P.O.A.D.P. & P.U.D. PLAN
for
THE RESERVE AT WESTOVER HILLS

Re: Reserve at Westover Hills POADP # 622

The documents submitted to the Planning Department for the Reserve of Westover Hills # 622 does not meet the requirements for acceptance for consideration of giving Preliminary Overall Area Development Plan (POADP) status.

Re: The Reserve at Westover Hills
P.O.A.D.P. and P.U.D.

PUD PLAN

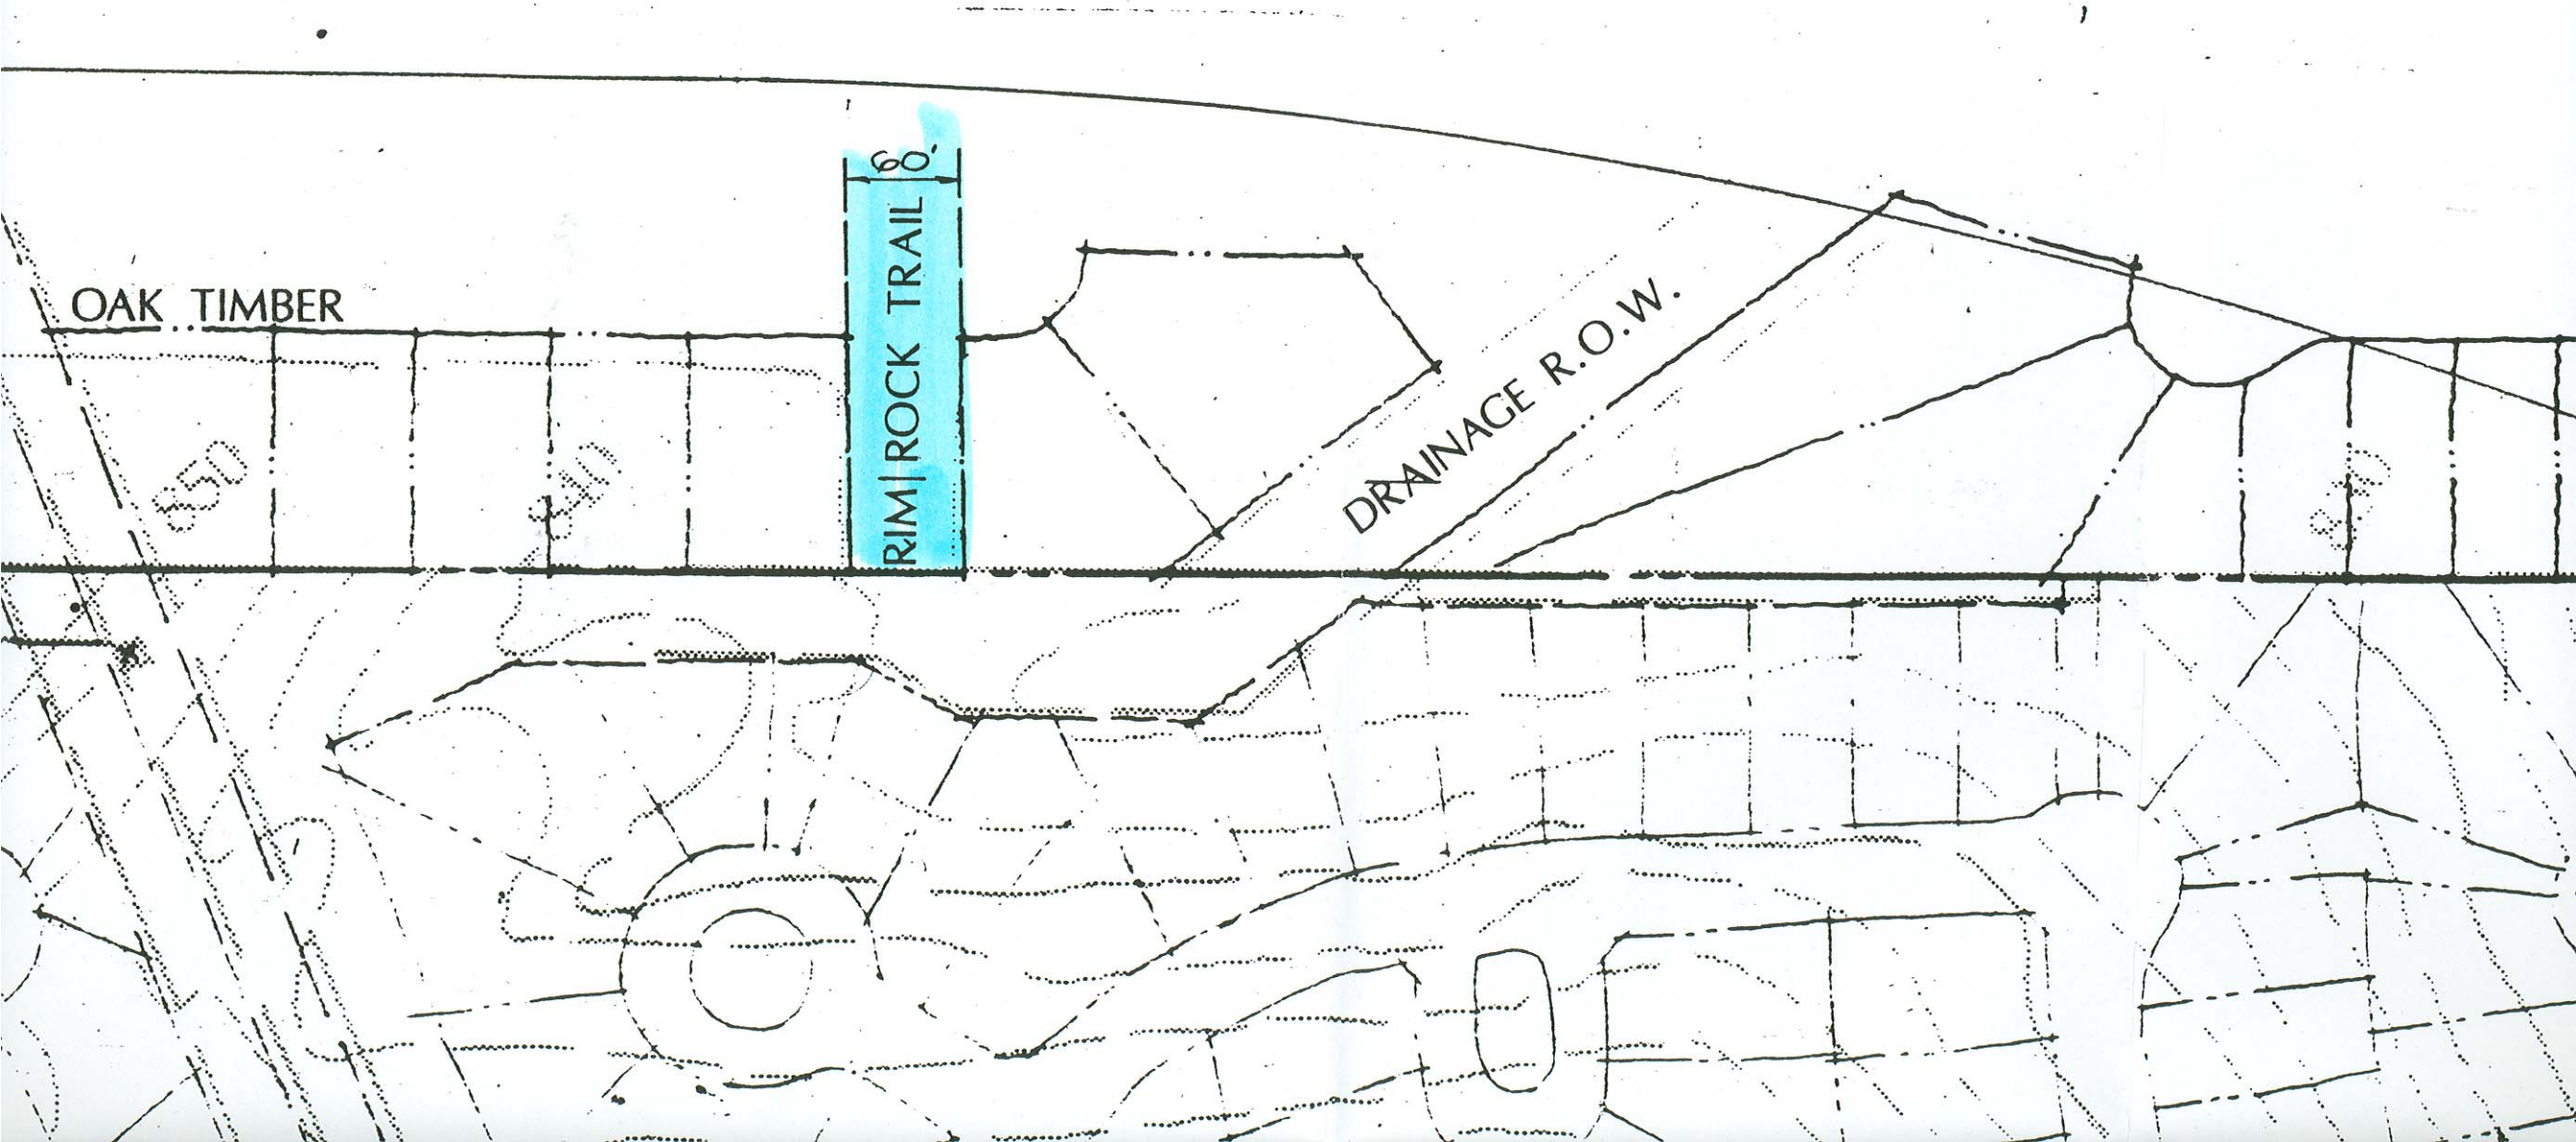
OAK TIMBER
RIM ROCK TRAIL
60'
DRAINAGE R.O.W.
850
840
830

Reserve @ Westover Hills
@ Military and Richland Hills
Inside City w/ 5 phases
354 SF Lots on 83 acres

- areal photo
- connectivity

- call School district to confirm School location.

- deny based on connectivity to adjacent to sub community
